KWM-380 TRANSCEIVER (622-5093-101)  
HF-380 TRANSCEIVER (622-3580-101)  
RECEIVER-EXCITER CIRCUIT CARD A3 (638-6908-001)

SERVICE BULLETIN NO 1

PRODUCT IMPROVEMENT

P/O Receiver-Exciter Card A3  
Figure 1

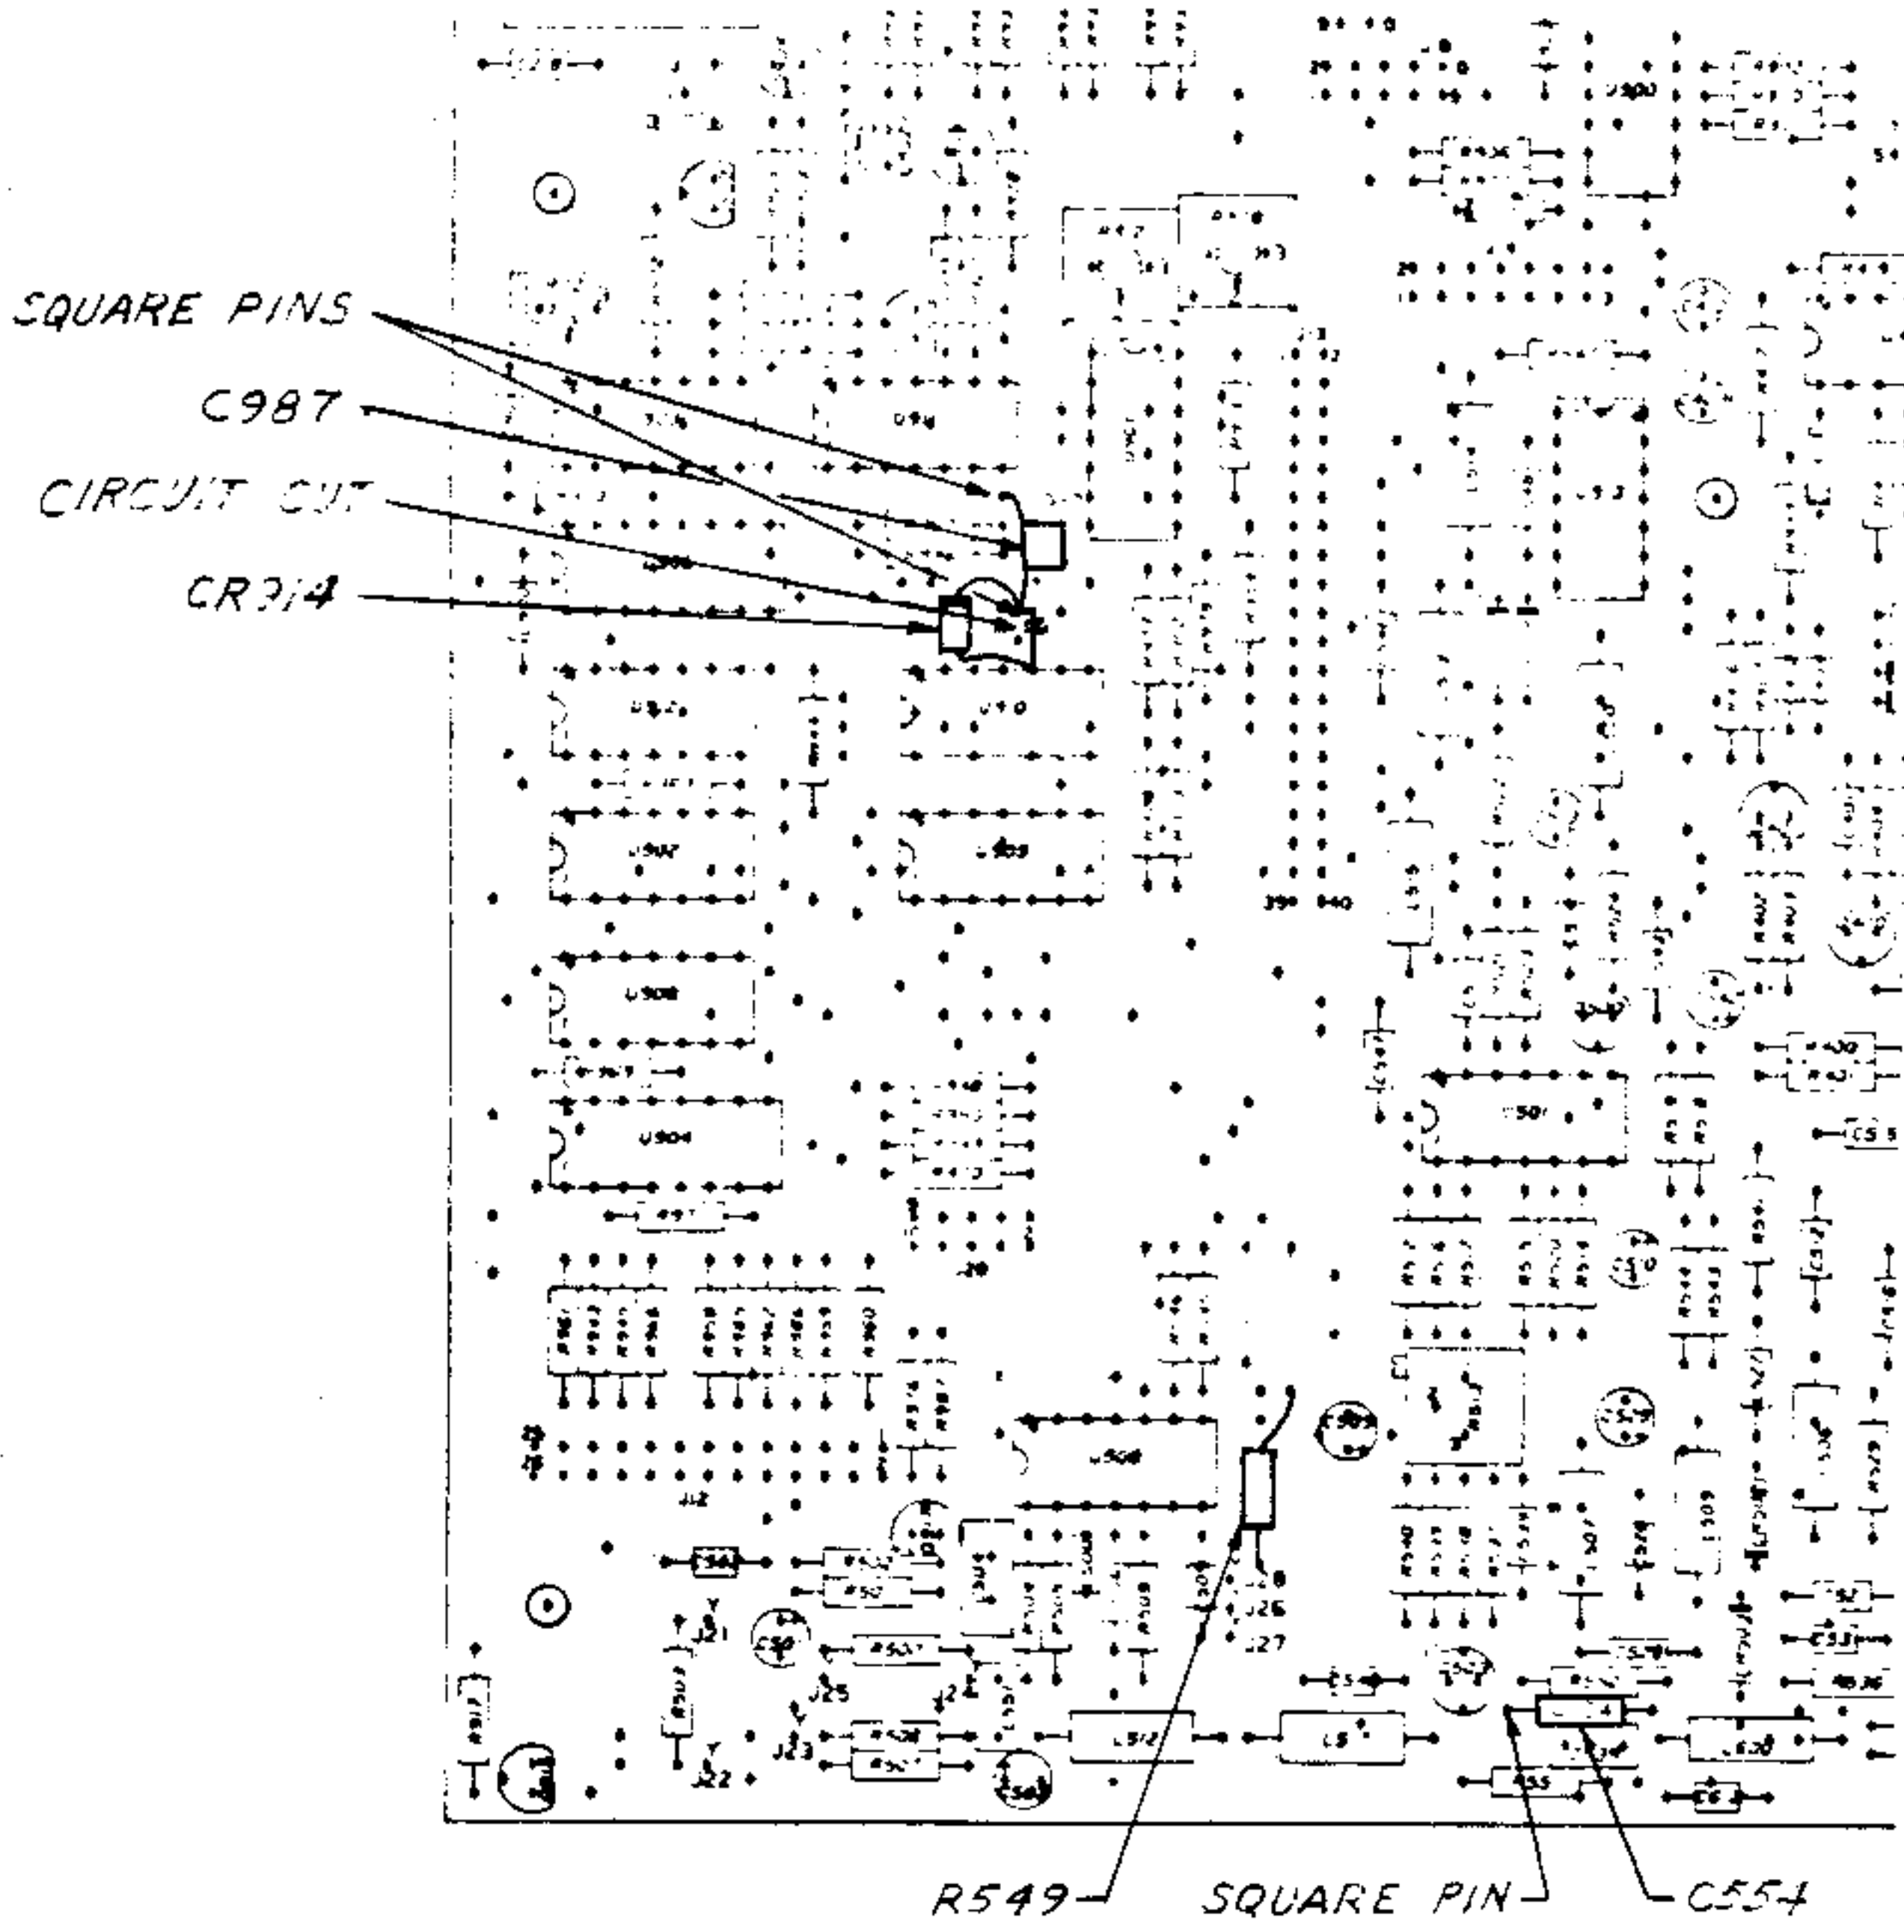
- M. Install 33-k $\Omega$  resistor R549 (745-0803-000) as shown in figure 1.
- N. Mark RWK REV R on the A3 circuit card near the existing REV letter.
- O. Plug the cables in that were removed in steps C and D.
- P. Reinstall the dust cover.
- Q. Mark SB 12 on the service bulletin information chart. If the transceiver does not have an information chart (280-3778-010), order one and attach it near the name-plate.

P/O Receiver-Exciter Assembly A3  
Figure 1

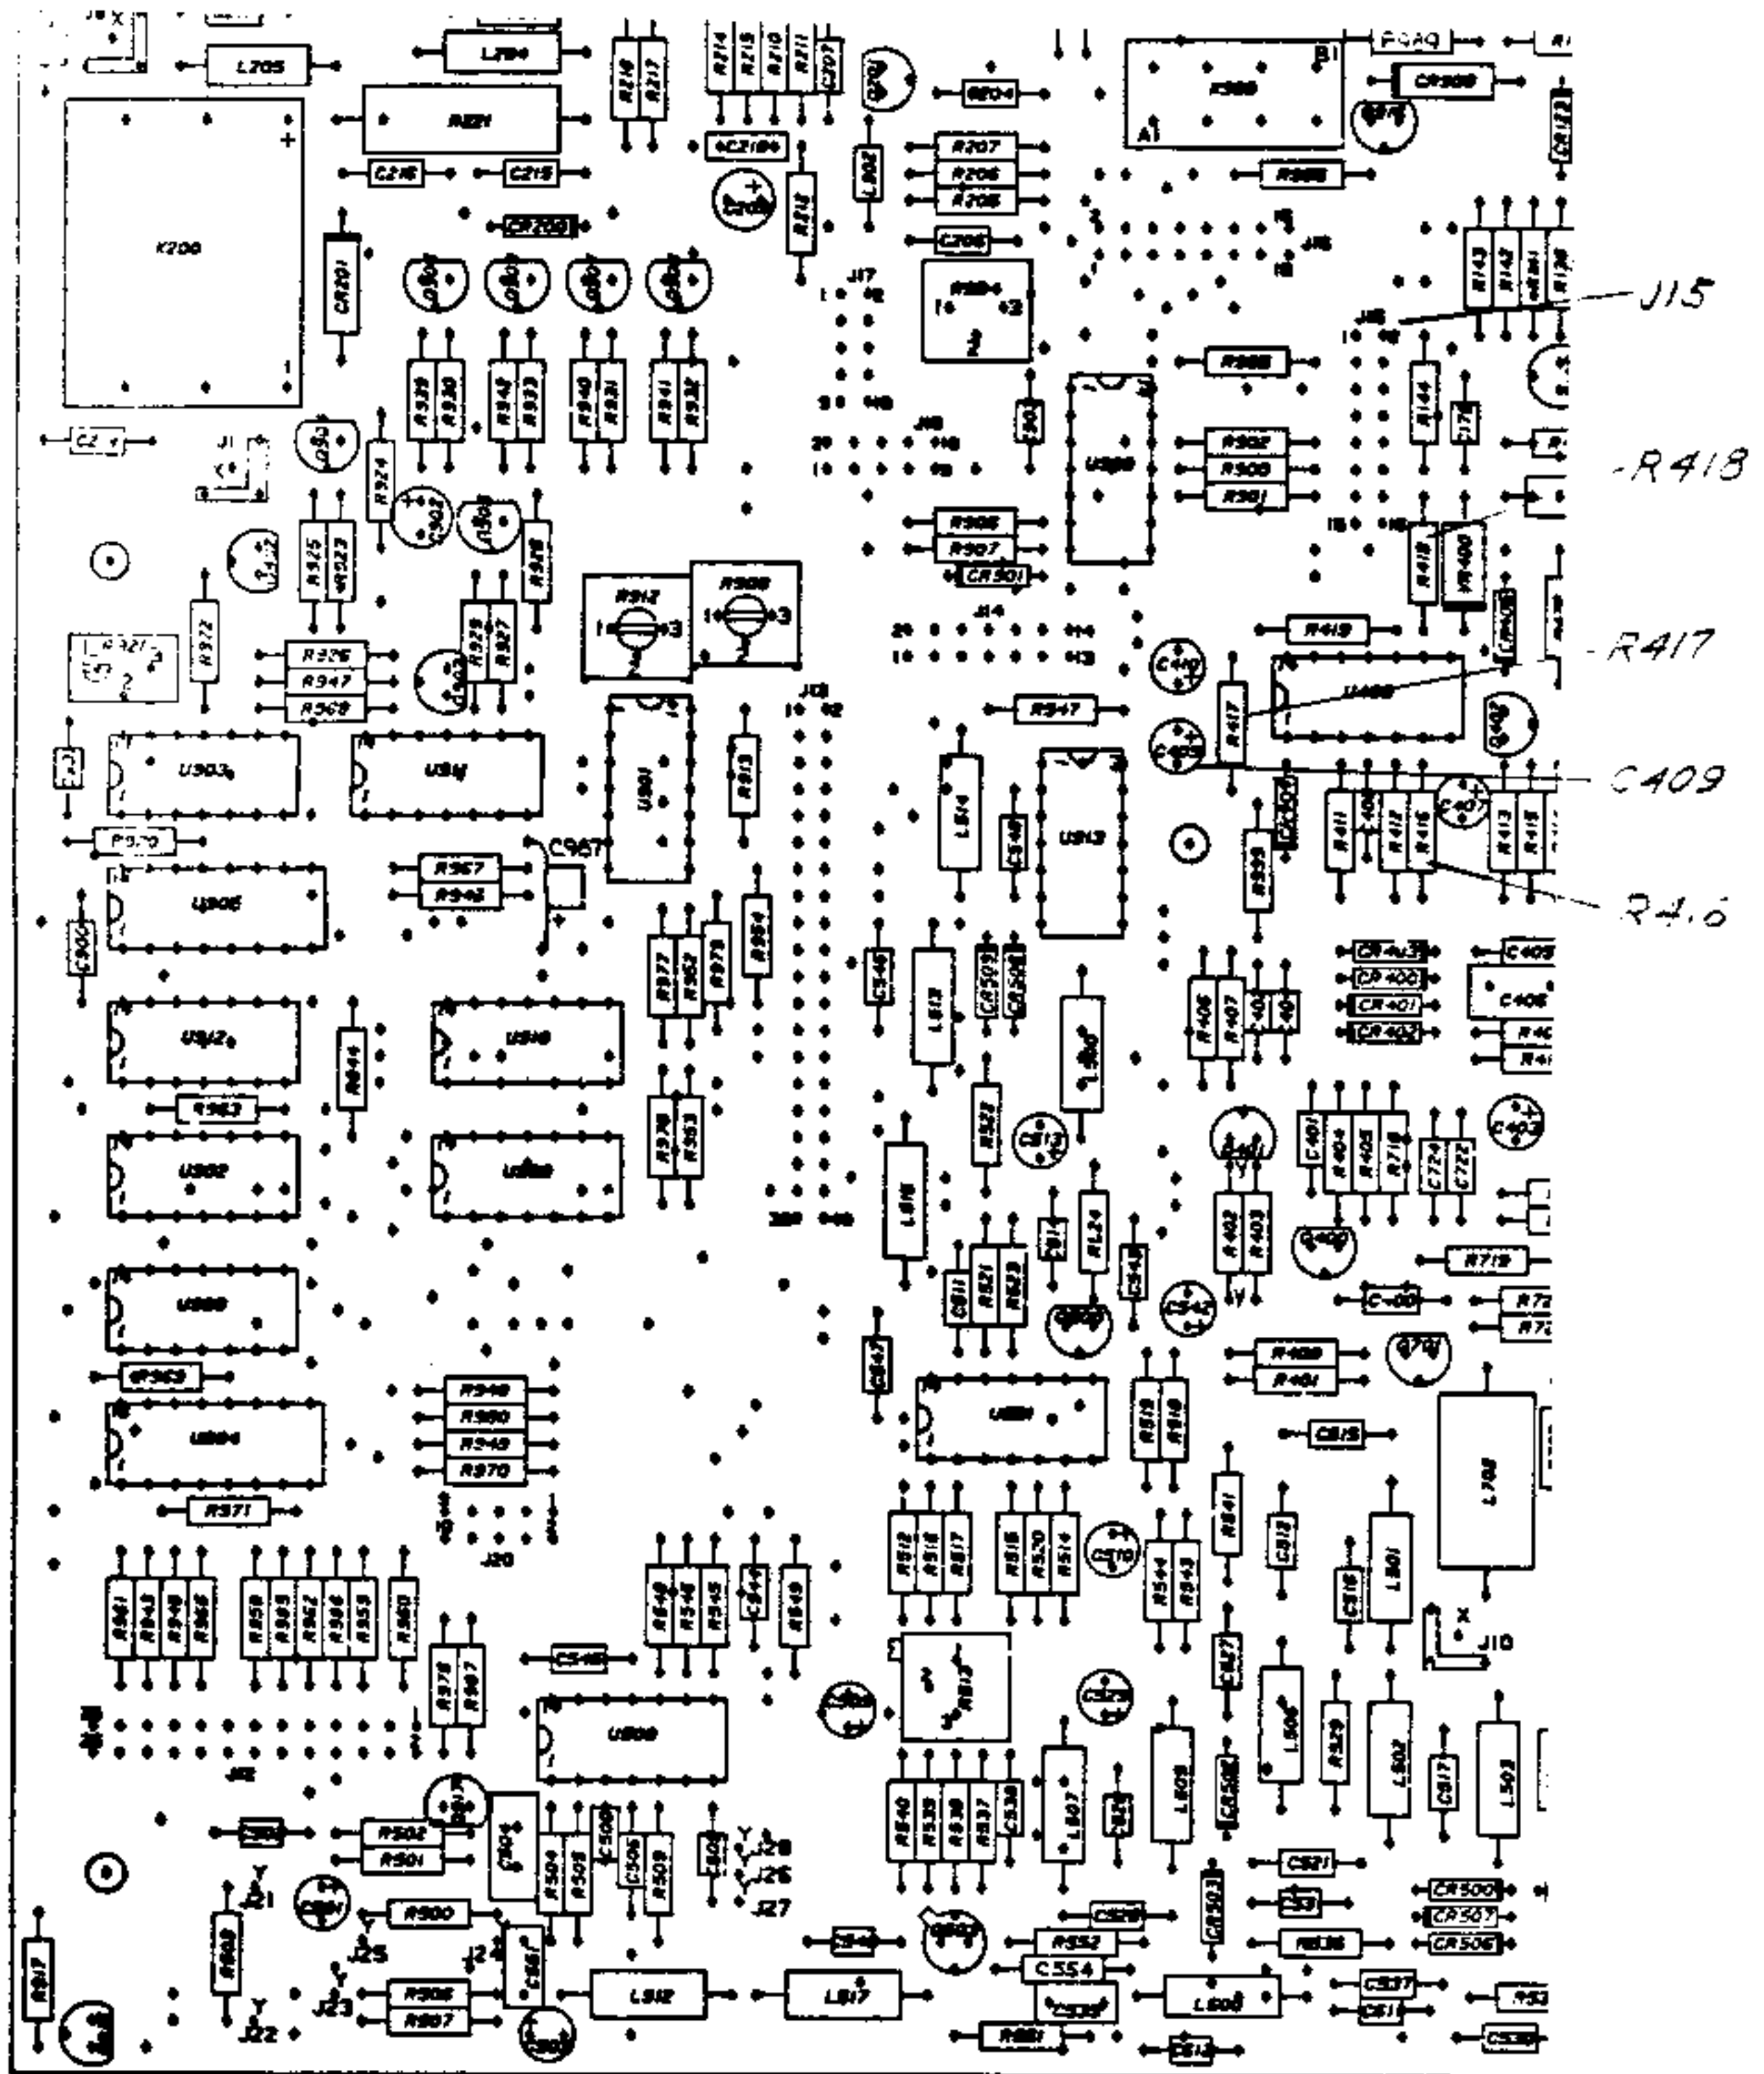
**NOTE:** Refer to figure 1 for location of components.

- D. Disconnect the cable connected to J15.
- E. Remove 3.3- $\mu$ F capacitor C409 and replace it with a new 1.0  $\mu$ -F capacitor (184-9102-350).
- F. Remove 2.2-M $\Omega$  resistor R416 and replace it with a new 3.3-M $\Omega$  resistor (745-0875-000).
- G. Remove 910- $\Omega$  resistor R417 and replace it with a new 2.7-k $\Omega$  resistor (745-0764-000).
- H. Remove 27-k $\Omega$  resistor R418 and replace it with a new 2.7-k $\Omega$  resistor (745-0764-000).
- I. Reconnect the cable that was removed from J15 in step D.
- J. Reinstall the dust cover.
- K. Mark SB 13 on the service bulletin information chart. If the transceiver does not have an information chart (280-3778-010), order one and attach it near the nameplate.
